# **PLANNING COMMITTEE**

**10<sup>th</sup> February 2021**

THE FOLLOWING ALTERATIONS AND AMENDMENTS HAVE BEEN RECEIVED SINCE THE PLANNING OFFICER'S REPORT WAS PRESENTED TO MEMBERS

**P/07584/011 Land at Stoke Wharf, Stoke Road & Land to west of 9 to 17 Kendal Close & Former builders merchants to rear and north of 132-144 Stoke Road & Bowyer Recreation Ground, Slough**

### Block C

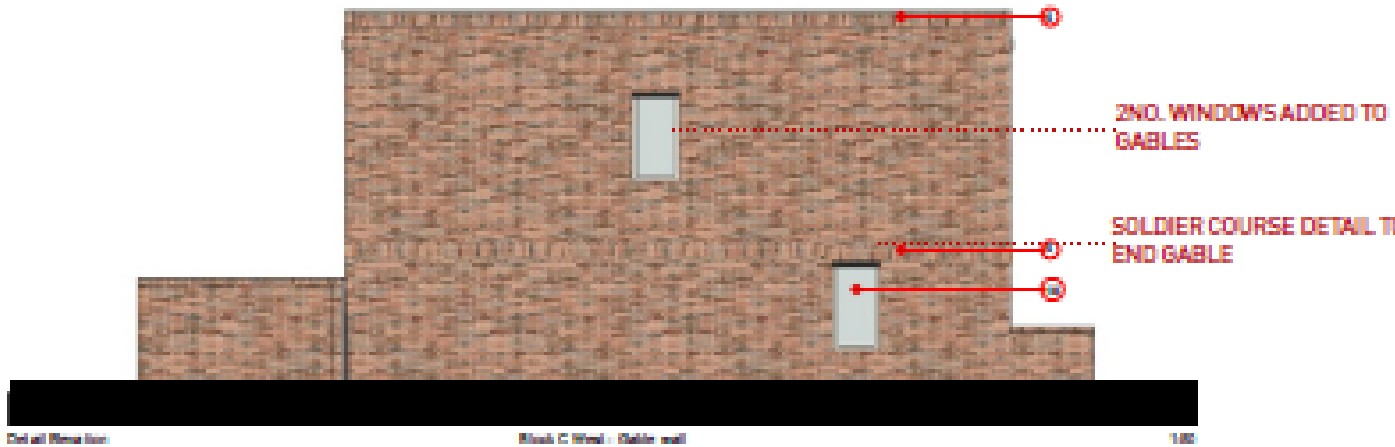
The intention of the proposed changes is

1. to protect the privacy of neighbours to the north from overlooking from the first floor bedrooms, which are located on the north side in each of the proposed houses, and
2. to introduce a design feature in the flank walls of the Block C houses, at both ends.

Point (i) in this proposal is introduced by the introduction of obscured glazing to a height of 1800mm above finished floor level.

North elevation, facing Shaggy Calf Lane properties. The blue arrow indicates proposed height of obscured glazing (1800mm).

West elevation, facing Stoke Road, showing additional flank wall windows.

With regards to overlooking, it is noted that first floor window-to-window separation from neighbours would be between 22 and 26m; however as noted at para.11.10 in the Committee report, the first floor rear windows at Block C would be set approximately 5m from the rear boundaries at the adjacent properties on Shaggy Calf Lane. It is noted that the introduction of obscure glazing to the rear facing windows would not address the issue of perceived overlooking for neighbours to the north, and it is also considered that this would not provide an acceptable level of amenity for the occupiers of these houses. It is therefore considered that further changes such as the introduction of angled bay windows should be made to address these issues, as part of any amended drawings that are submitted by the applicant.
